Planning Commission
October 15, 2024 - 6:00 PM
233 South Main Street, Monroe, Ohio

DATE: October 15, 2024
RE: Information Packet for October 15, 2024 Planning Commission Meeting at 6:00 p.m.

I. Case No. 2024-10-6— Public Hearing—Consideration of a Conditional Use Permit for the expansion of Monroe First Church of God

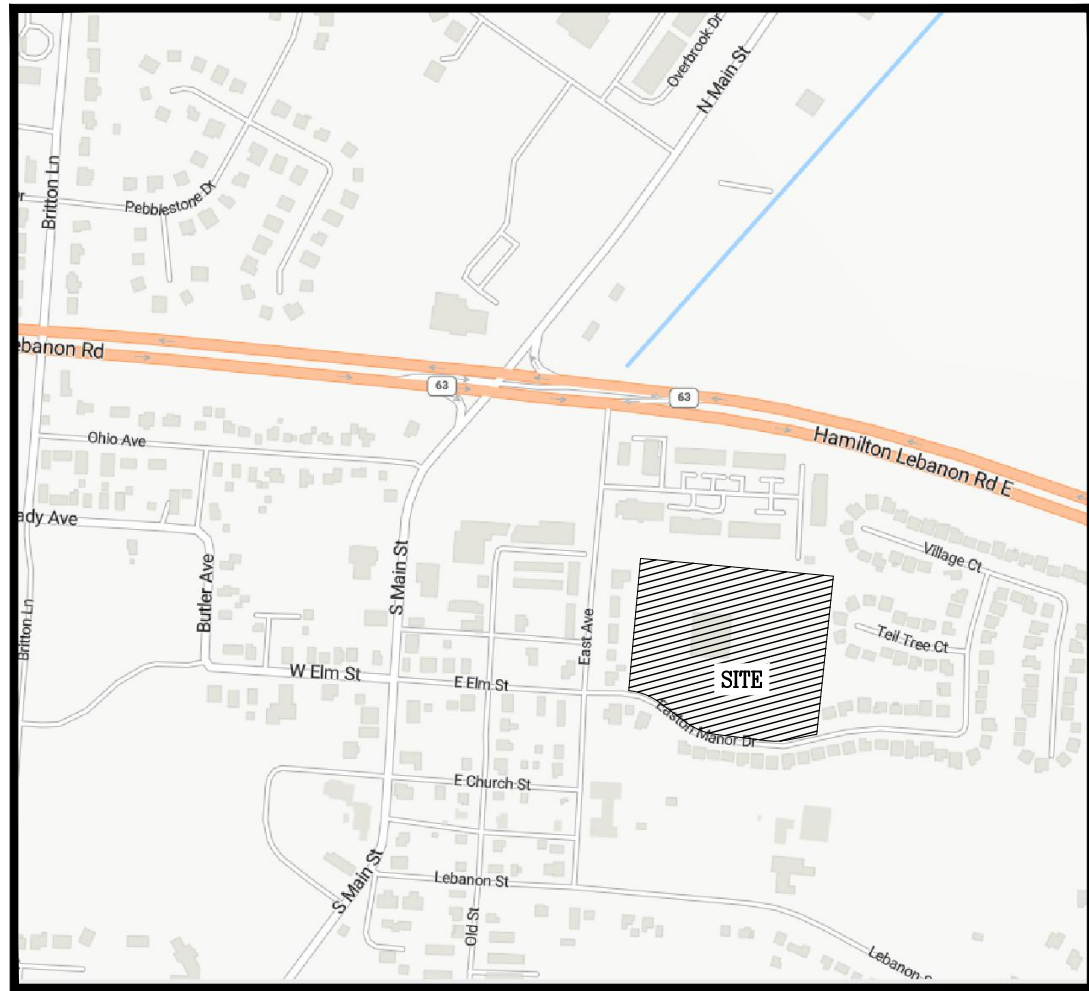
- i. Interior required = 2
 - ii. Interior shown = 0
 - iii. Missing = 2
3. A minimum 20% of the required front yard area must be landscaped. Staff requests missing front yard landscaping along Easton Manor Drive be provided in a revised landscape plan.

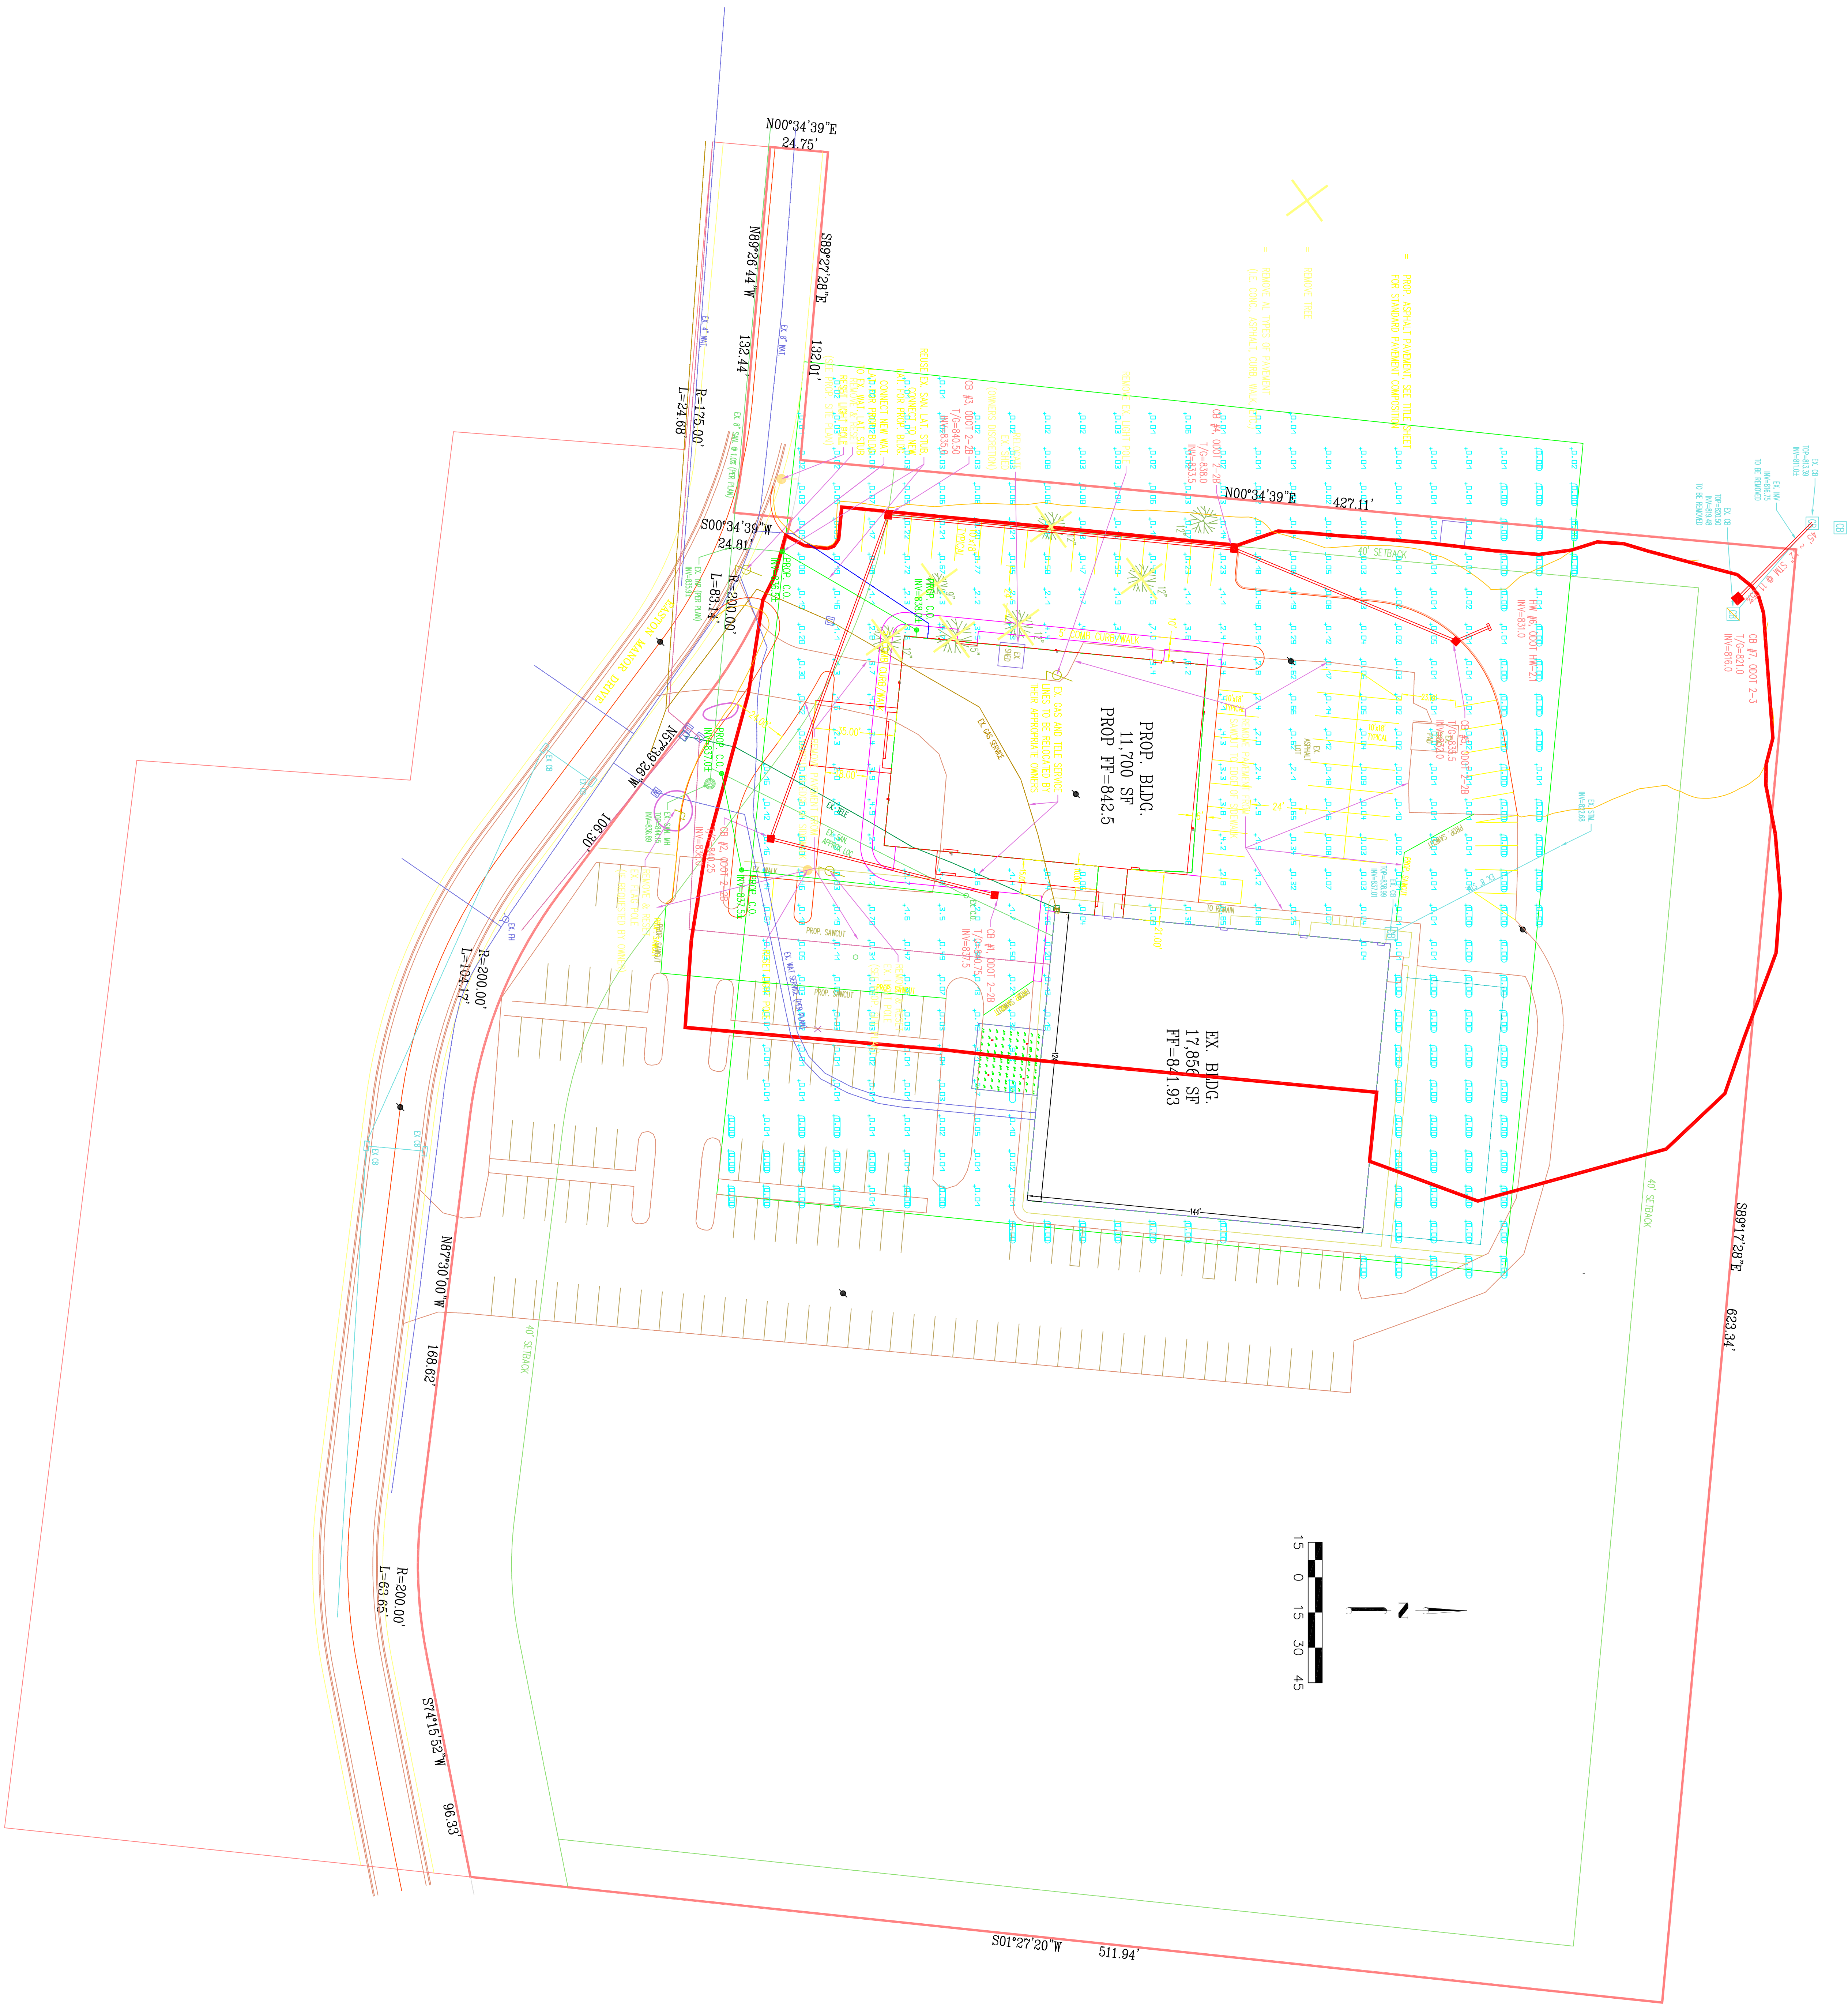
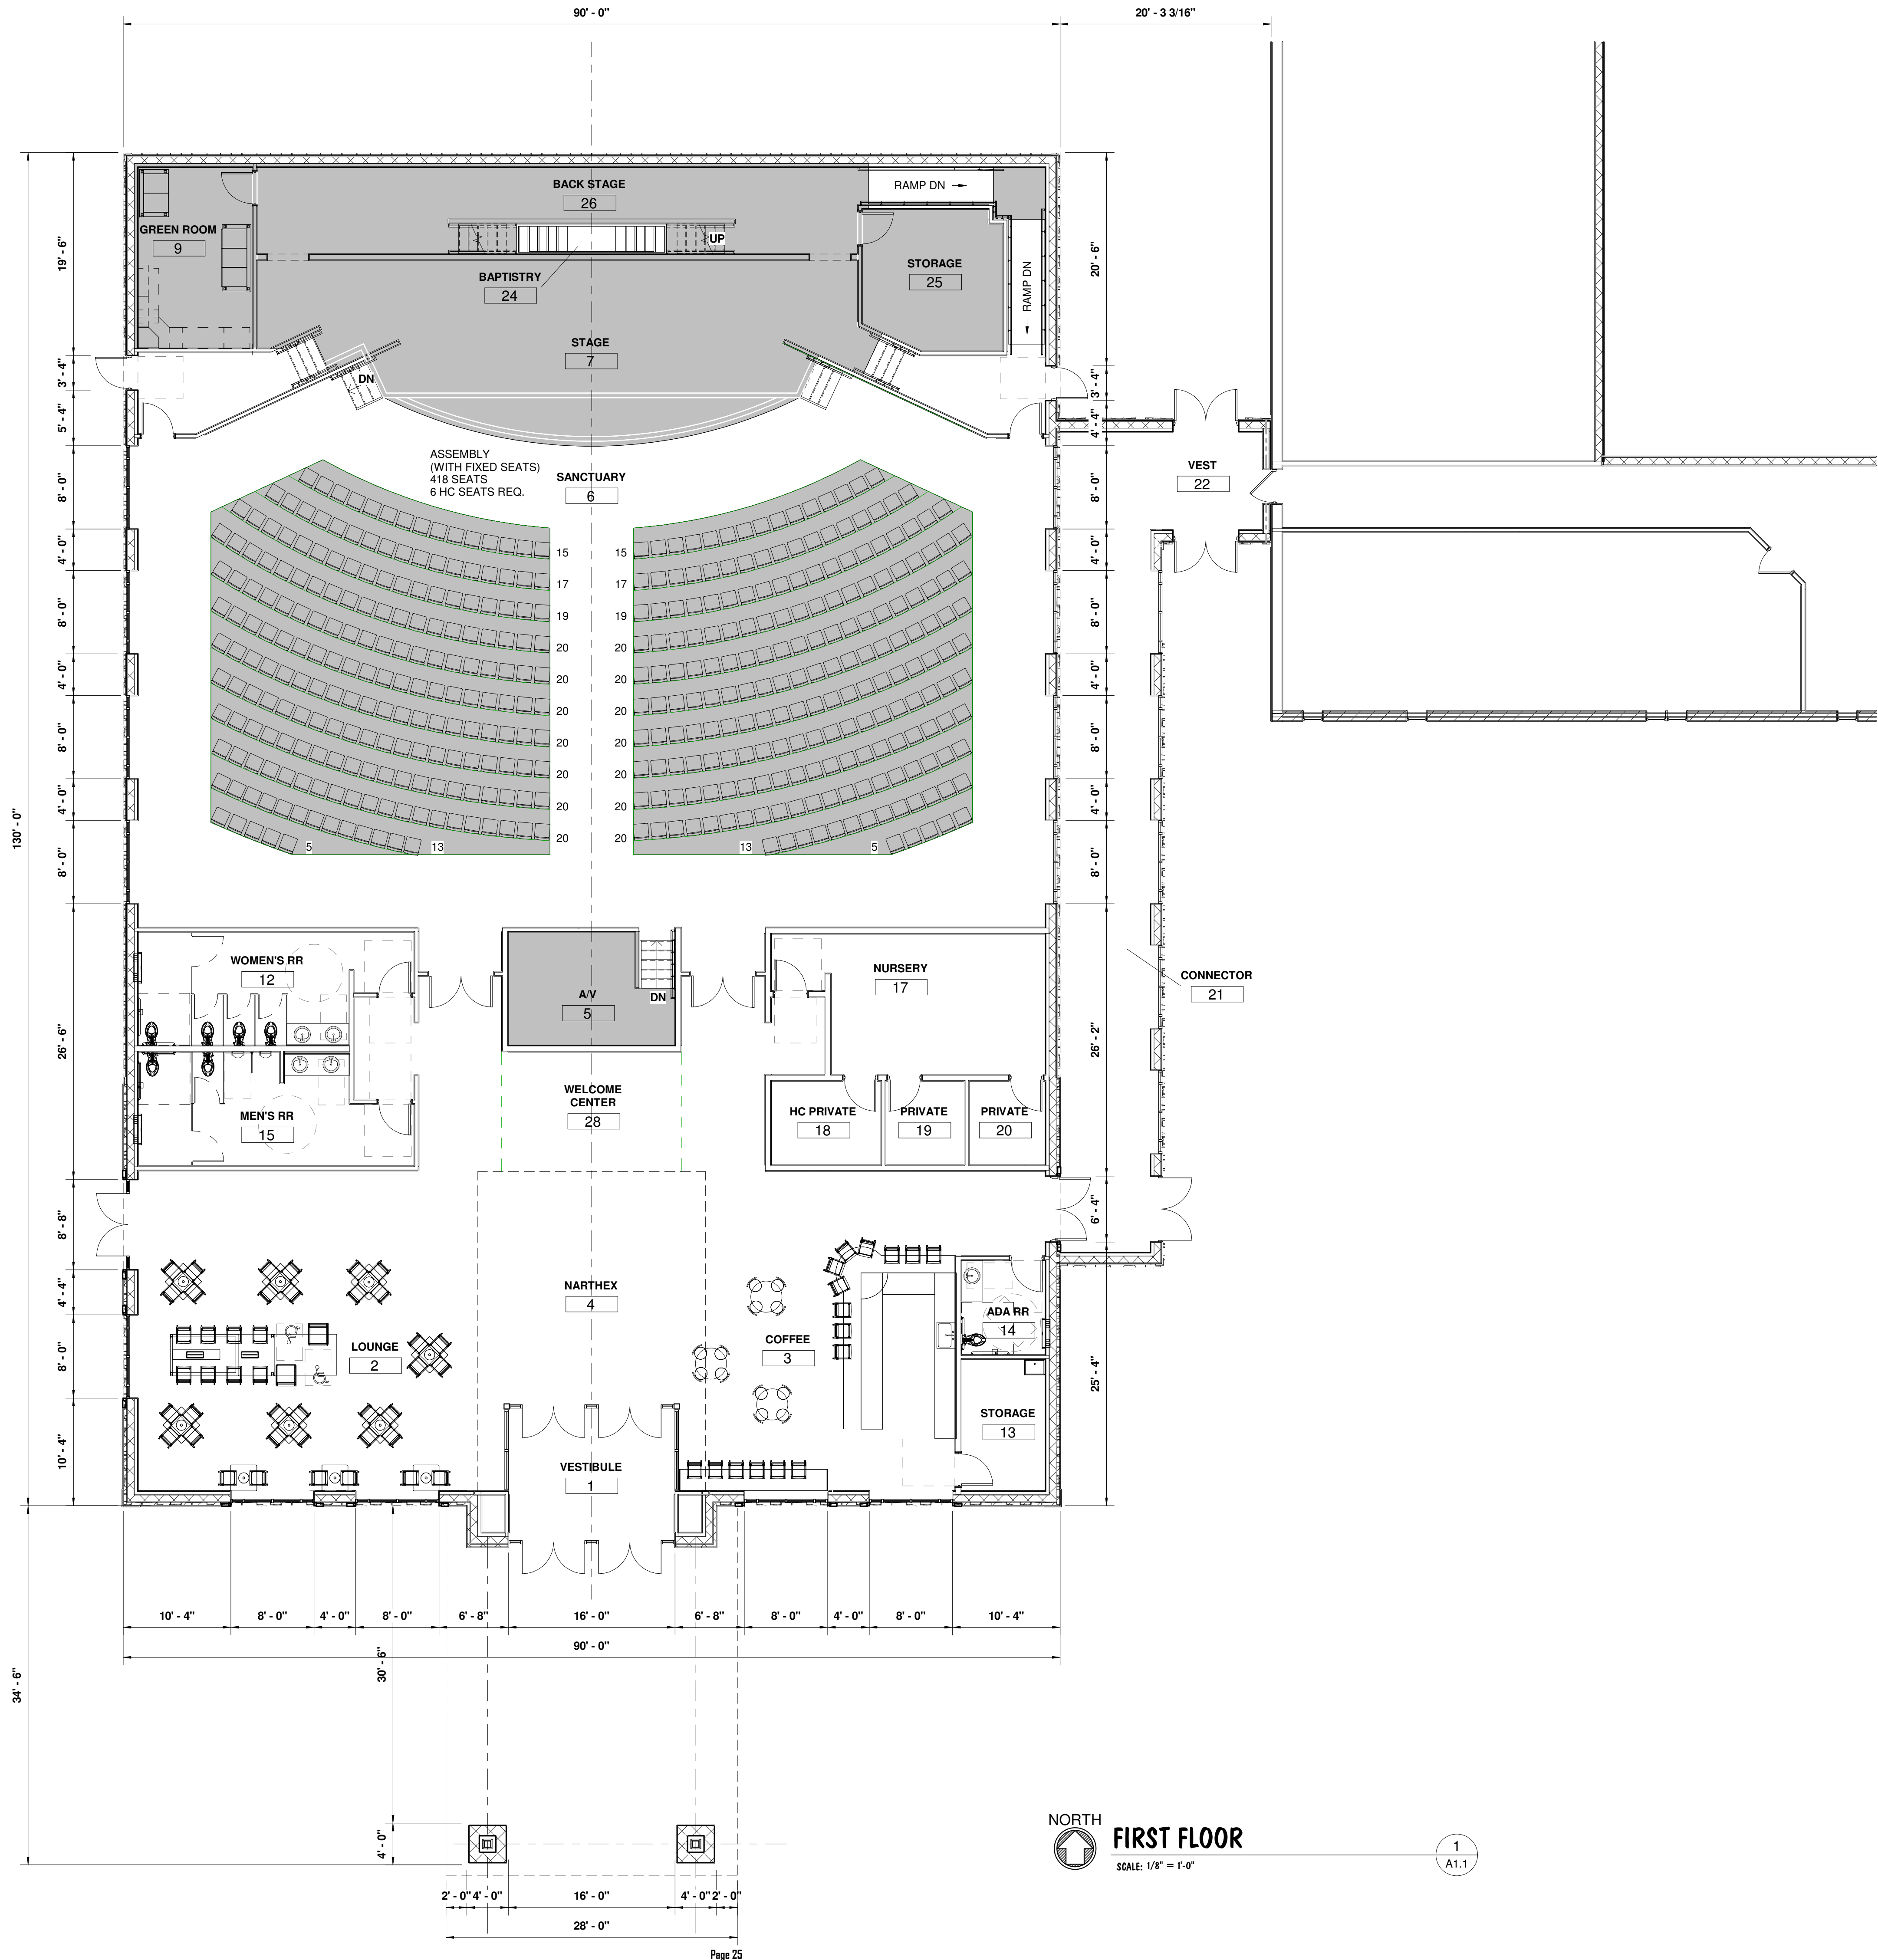
As found in staff comments below, the proposed lighting plan does not meet minimum illumination standards. While it may be appropriate to increase the lighting on the east side of the developed part of the site, having less (but safe) amounts of lighting in the parking area may be appropriate in addition to maintaining the vegetated open space between the church and the homes in the Easton Manor subdivision.
